Service Bulletin

Bulletin No.: 22-NA-067

Subject: Poor Engine Performance, PCV Bypass Hose and Charge Air Cooler (CAC) Restricted for LUV Engines, Malfunction Indicator Lamp (MIL) Illuminated - DTC P0299, P0234, P0236, P2261, P2227, P00C7 Set

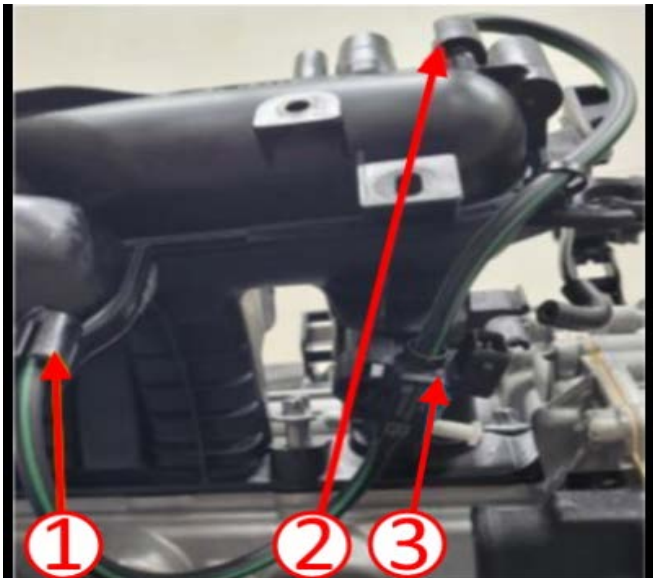
4. Inspect the PCV intake runner for blockage (carbon/oil/water/sludge/ice) build-up blocking the cylinder head as shown above.

5. Clean any ice/sludge/water/carbon out of the cylinder head, cam cover and PCV pipes.

If above condition exists, then replace the intake manifold. Refer to *Intake Manifold Replacement* in SI.

Old Design Intake Manifold

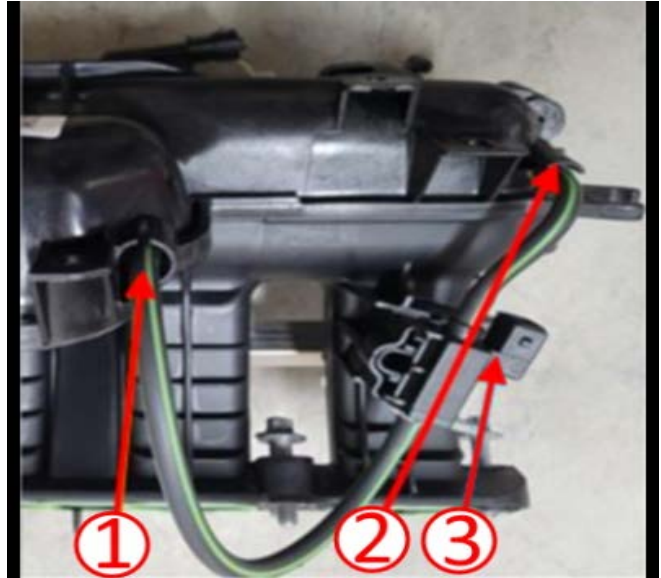
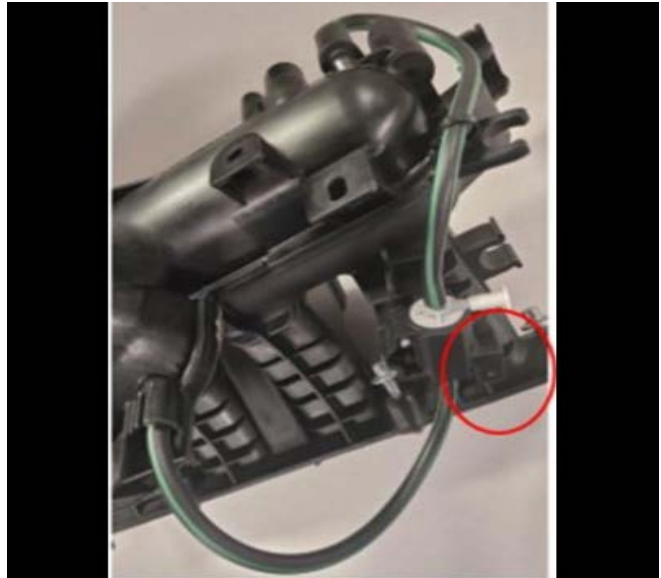
New intake manifold with a re-designed intake positive pressure port location. Solenoid location is electrical connector forward. The vacuum feed is in the same location. If the solenoid is found to be loose, review the location of the electrical connector. If the connector is facing the head of the assembly, it is installed backwards and will need to be removed and installed correctly.

- Bypass Valve Vacuum (1)
- Intake Positive Pressure Port (2)
- Solenoid/Electrical Connector (3)

- Bypass Valve Vacuum (1)
- Intake Positive Pressure Port (2)
- Solenoid/Electrical Connector (3)

Note: The electrical receptacle location. Remove and re-install the lines and solenoid as they are retained to the intake if installed incorrectly. Tabs reversed, the solenoid is keyed and will not be seated in retainers.

New Design Intake with incorrect solenoid installation.

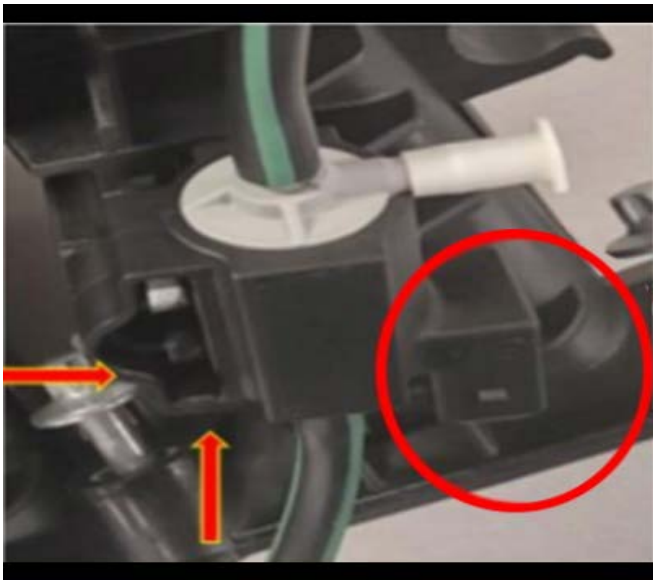
New Design Intake with solenoid retainers not seated and the electrical connector facing the cylinder head. Keyed section of intake not level with solenoid body.
